THI QAR BEE FARM
THI QAR, IRAQ

SIGIR PA-09-188
APRIL 1, 2010

SUBJECT: Report on the Thi Qar Bee Farm, Thi Qar, Iraq (SIGIR Report Number
PA-09-188)

Figure 1. Conceptual design of honey processing facility (Courtesy of GRS)

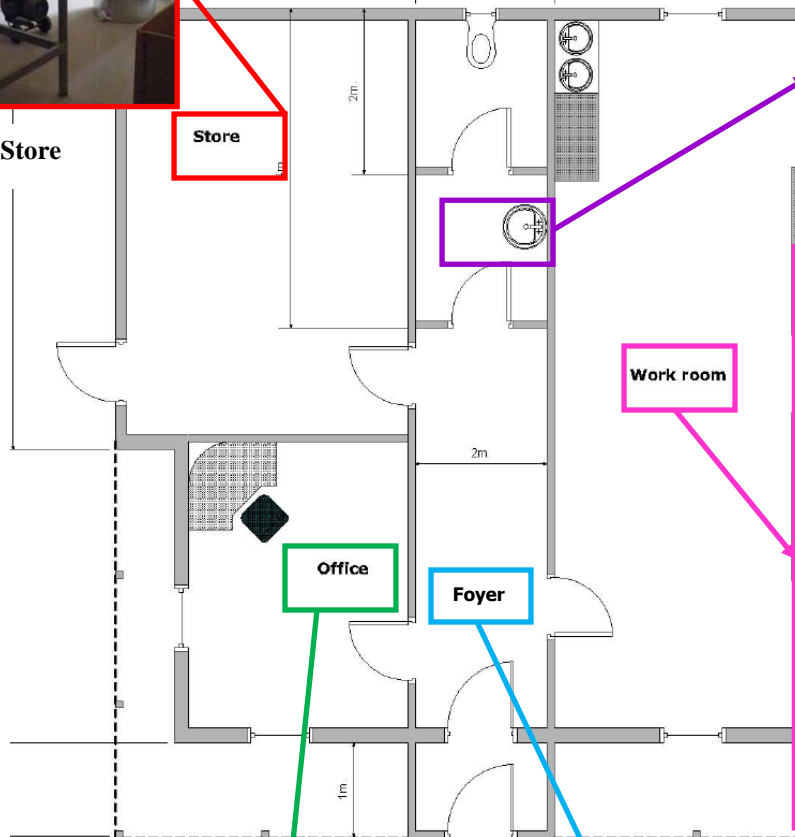
The building was constructed with three primary rooms and one restroom (Figure 1). The finish in all of the rooms was similar—plaster and painted finish for the walls, and ceramic tiles for the flooring. The finishes appeared well applied and in good condition.

When entering the building through the foyer, the office and store are located on the left, the restroom is straight ahead, and the work room is on the right. The store area was equipped for processing honey and was well-maintained (Site Photo 7). Several tables were available for workers to perform the various tasks required for processing, and equipment was located in this area.
